Access Compliance Report

Public Rights-of-Way

(Curb Ramps)

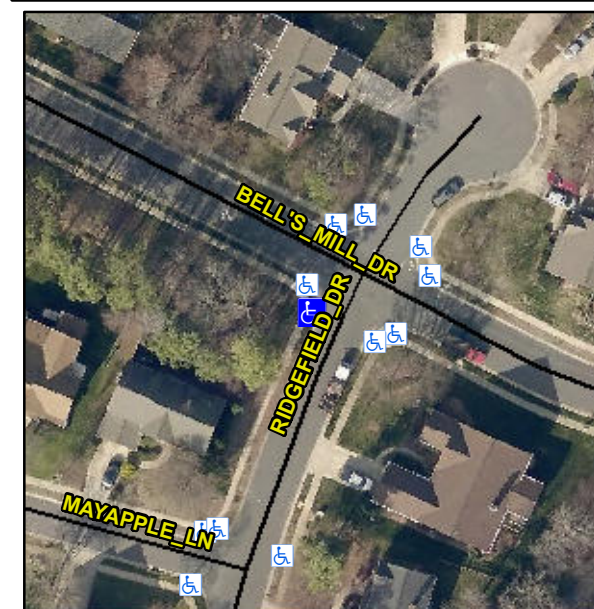
Intersection ID: 2755	Main Street: BELL'S_MILL_DR	Cross Street: RIDGEFIELD_DR	Location: W
ADA ID: E6B344C404DC	Ramp Type: Perp	Initial Pass/Fail: Fail	Overall Compliance: No
Severity Score: 33.75			
Codes/Mitigation Info/Possible Solution		Field Measurements/Component Compliance

R304.5.1, R304.2.2

Compliance	Description	Data	Compliance	Description	Data
N/A	Ramp Length (in)	58.0	No	Ramp Slope (%)	13.8
No	Ramp Width (in)	36.0	Yes	Ramp XSlope (%)	0.2
N/A	Flare Type LT	N/A	N/A	Flare Type RT	N/A
N/A	Flare Slope LT (%)	N/A	N/A	Flare Slope RT (%)	N/A
N/A	Flare Traversable LT?	N/A	N/A	Flare Traversable RT?	N/A
N/A	Landing Length (in)	N/A	N/A	DWS Provided?	N/A
N/A	Landing Width (in)	N/A	N/A	DWS Contrast?	N/A
N/A	Landing Slope (%)	N/A	N/A	DWS Length (in)	N/A
N/A	Landing X Slope (%)	N/A	N/A	DWS Full Width?	N/A
N/A	Landing Curb? (Y/N)	N/A	N/A	DWS Offset (in)	N/A
N/A	Shared Landing?	N/A			
N/A	Gutter Ponding?	N/A	N/A	Gutter Slope (%)	N/A
N/A	Gutter Lip Ht (in)	N/A	N/A	Gutter X Slope (%)	N/A
N/A	Painted X Walk1?	No	N/A	Painted X Walk2?	N/A
	X Walk 1 Direction	To SE		X Walk 2 Direction	N/A
N/A	X Walk 1 Width (in)	N/A	N/A	X Walk 2 Width (in)	N/A
	X Walk 1 Slope (%)	0.7		X Walk 2 Slope (%)	N/A
	X Walk 1 X Slope (%)	2.2		X Walk 2 X Slope (%)	N/A

Remove & Replace Entire Ramp.
